DEVELOPMENT PLAN APPLICATION SUMMARY

File Number	DP-25-8
Property Address	191 GRANVILLE ST GAHANNA, OH 43230
Parcel ID	025-000281
Zoning District	CMU - Creekside Mixed-Use
Project/Business Name	Northwest Bank
Applicant	Andrew Gardner agardner@v3co.com 614-226-3650
Description of the Request	Renovation of the existing building for a new Northwest Bank Branch. New Parking and utilities will be installed.

PLANNING COMMISSION STAFF REPORT

Meeting Date: August 27, 2025

1 LANDSCAPE PLAN
1"=20'

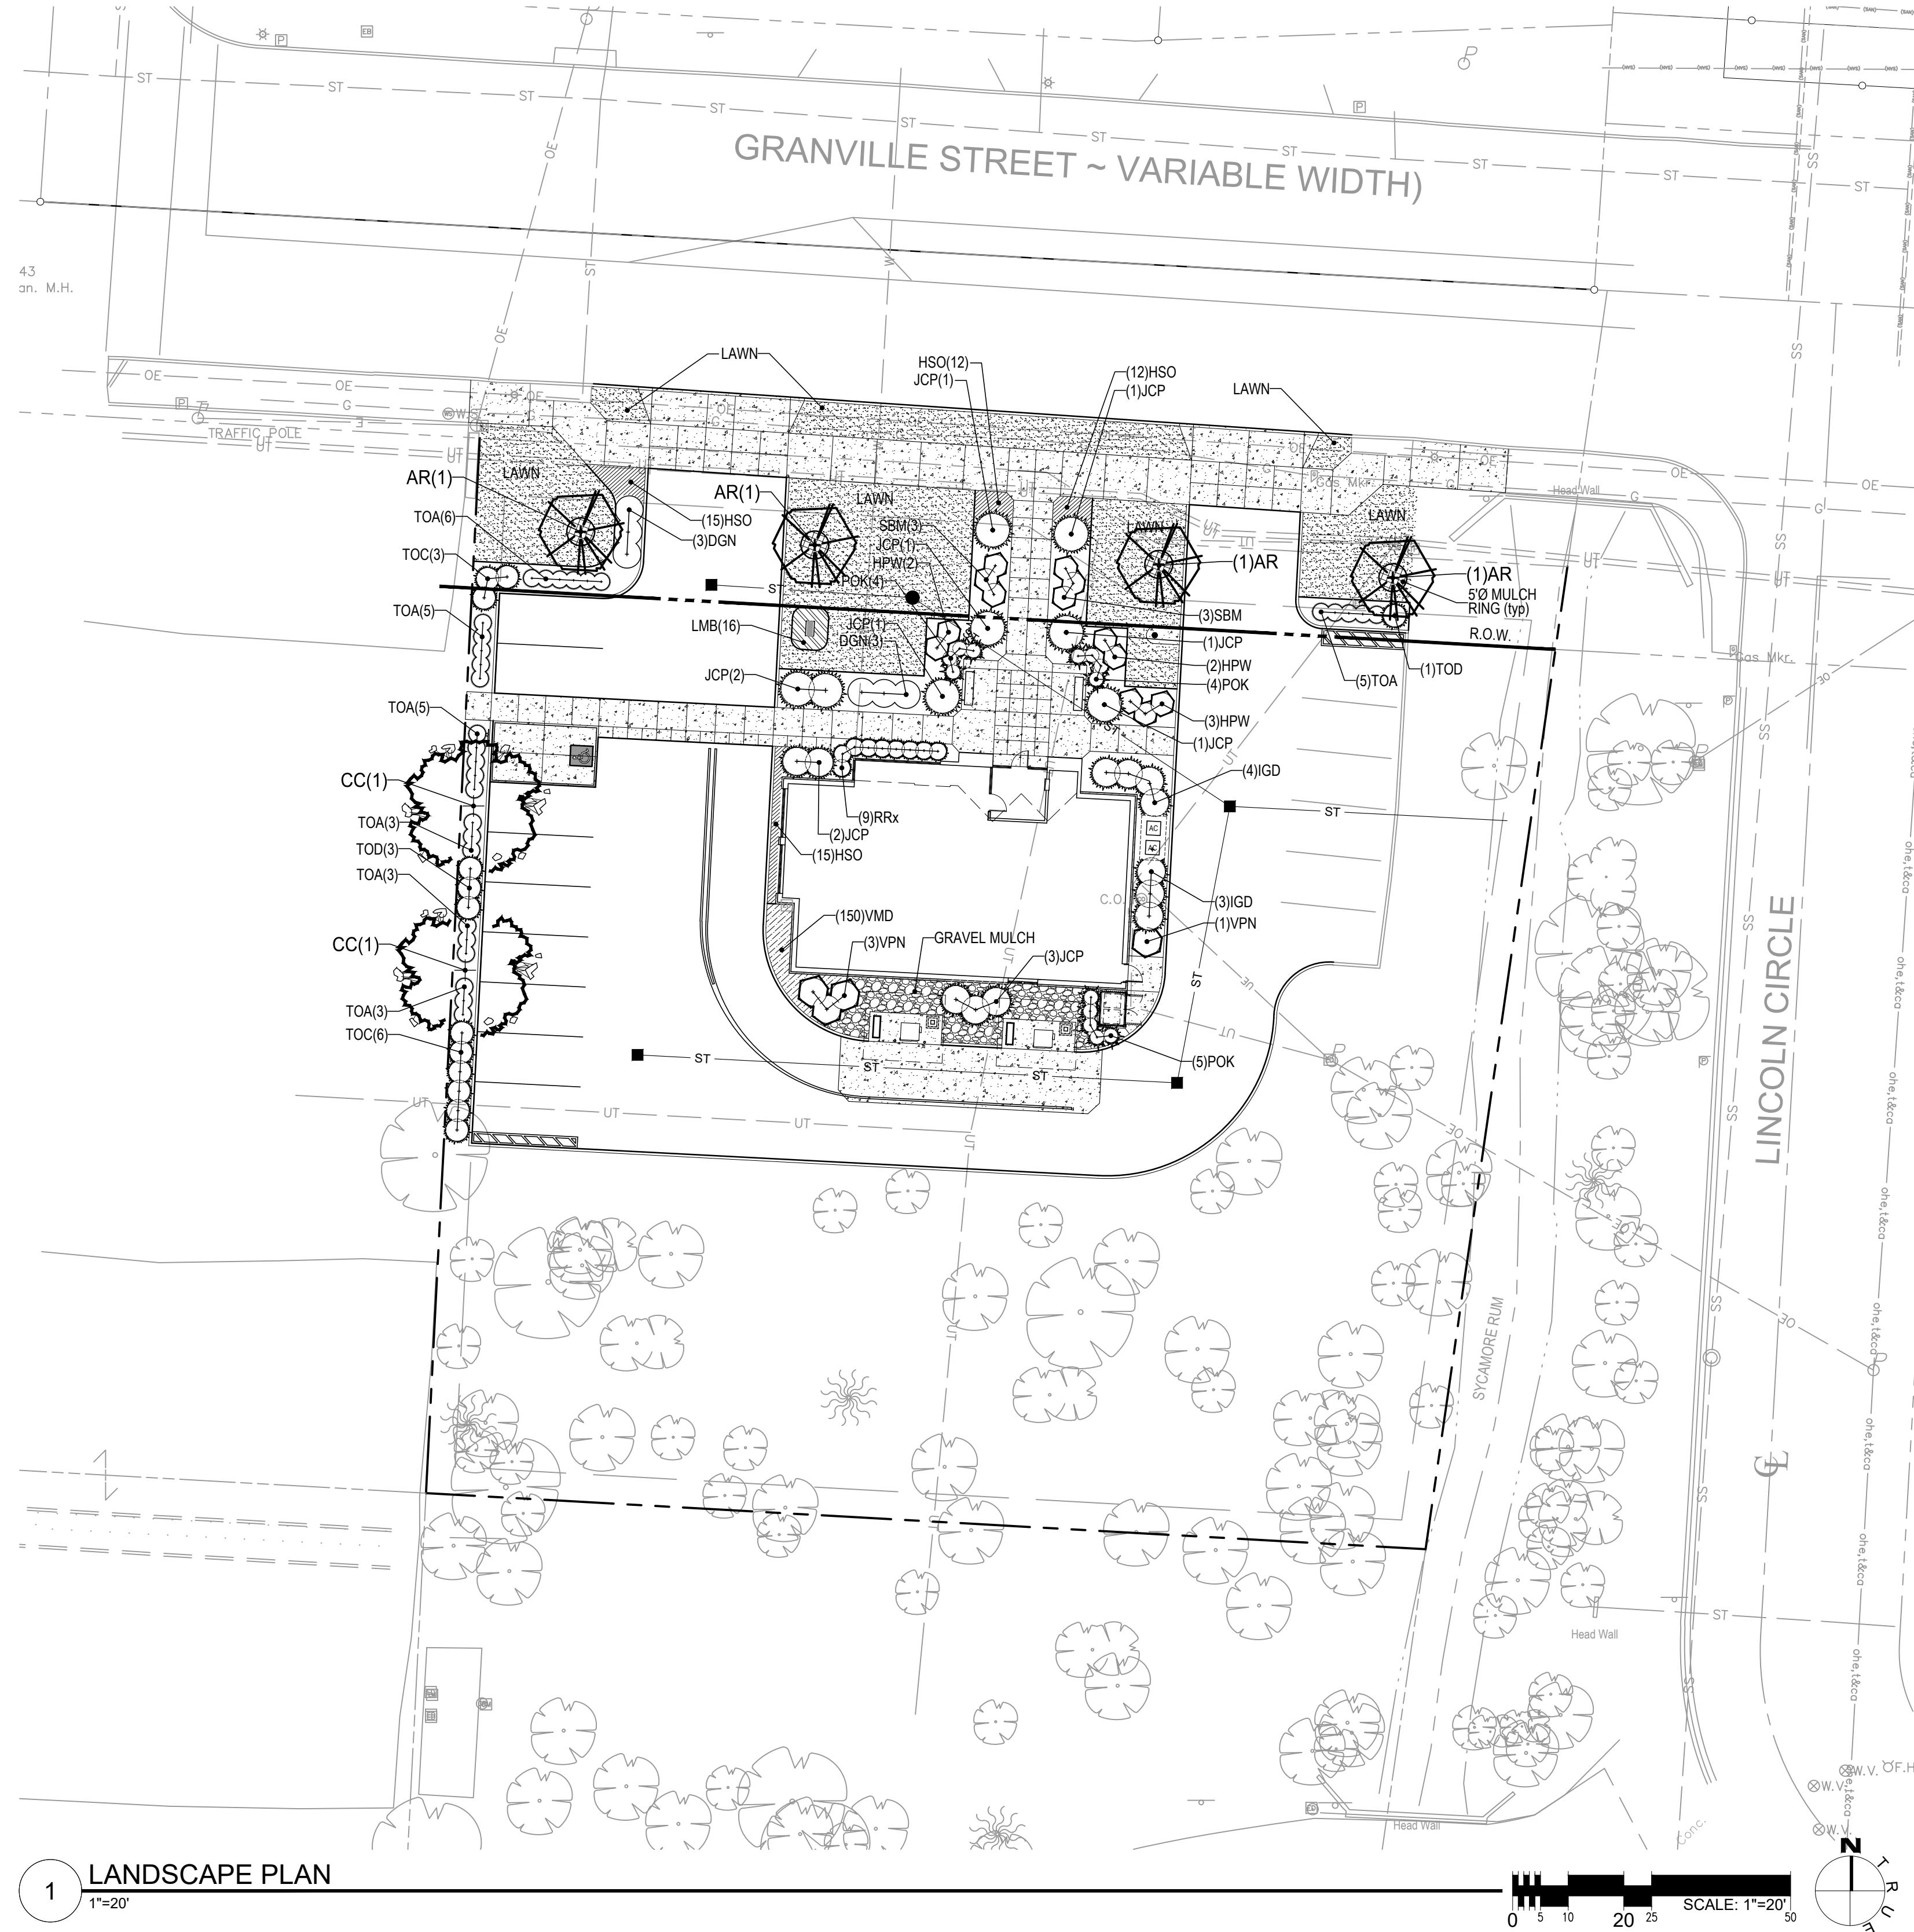
The parking area will be screened from the ROW and adjacent property by 3 ft high shrubs. The landscape plan also shows four new trees and assorted shrubbery and ground cover in the parking area and to the front of the building. All landscaping requirements are met.
